Access Compliance Report Public Rights-of-Way (Curb Ramps)

Main Street: GILLY_FLOWER_ST		Cross Street: ZINNIA_ST		Location:	S
ADA ID: RPRK211111140237	Ramp Type: Type 4 - Parallel	Initial Pass/Fail: Fail	Overall Compliance: No	Severity Score:	15

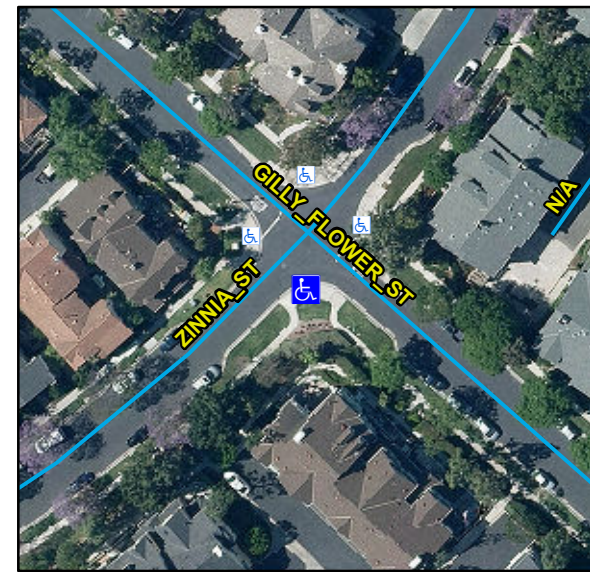
R304.2.2, R204.3, R304.5.3, STD 1115

Compliance	Description	Data	Compliance	Description	Data
N/A	Ramp Length LT (in)	135	N/A	Ramp Length RT (in)	131
Yes	Ramp Width LT (in)	89	Yes	Ramp Width RT (in)	89
Yes	Ramp Run Slope LT (%)	4.9	Yes	Ramp Run Slope RT (%)	2.6
No	Ramp Cross Slope LT (%)	5.8	No	Ramp Cross Slope RT (%)	5
N/A	Landing Present	N/A	N/A	DWS Provided	N/A
N/A	Landing Length (in)	N/A	N/A	DWS Contrast	N/A
N/A	Landing Width (in)	N/A	N/A	DWS Length (in)	N/A
N/A	Landing Run Slope (%)	N/A	N/A	DWS Full Width	N/A
N/A	Landing Cross Slope (%)	N/A		DWS Offset Type	N/A
N/A	Landing Movement Obstructed?	N/A	N/A	DWS Offset Left (in)	N/A
	Landing Movement Type	N/A	N/A	DWS Offset Right (in)	N/A
N/A	Landing Shared	N/A			
N/A	Clear Space	Yes			
N/A	Clear Space To Crosswalk (in)	N/A			
N/A	Marked Crosswalk 1	No	N/A	Marked Crosswalk 2	No
	Crossing 1 Direction	NE		Crossing 2 Direction	NW
	Marked Crosswalk 1 Width (in)	N/A		Marked Crosswalk 2 Width (in)	N/A

N/A	Ramp Inside Crosswalk 1	N/A	N/A	Ramp Inside Crosswalk 2	N/A
	Crossing 1 Slope (%)	1.1		Crossing 2 Slope (%)	1
	Crossing 1 Cross Slope (%)	0.7		Crossing 2 Cross Slope (%)	2.5
N/A	Gutter Ponding	N/A	No	Curb Slope	11.8
Yes	Gutter Lip Height (in)	0		Road Run Slope (%)	1.2
N/A	Gutter Run Slope (%)	N/A		Road Cross Slope (%)	1.6
N/A	Gutter Cross Slope (%)	N/A	No	Perpendicular Joint Present	No
Yes	Overall Surface Condition	Acceptable			
	Cross Gutter Present?	No		Spandrel Present?	No
	Replace Cross Gutter?	N/A		Replace Spandrel?	N/A

Remove & Replace Curb Ramp With Two New Directional Ramps or Equivalent.
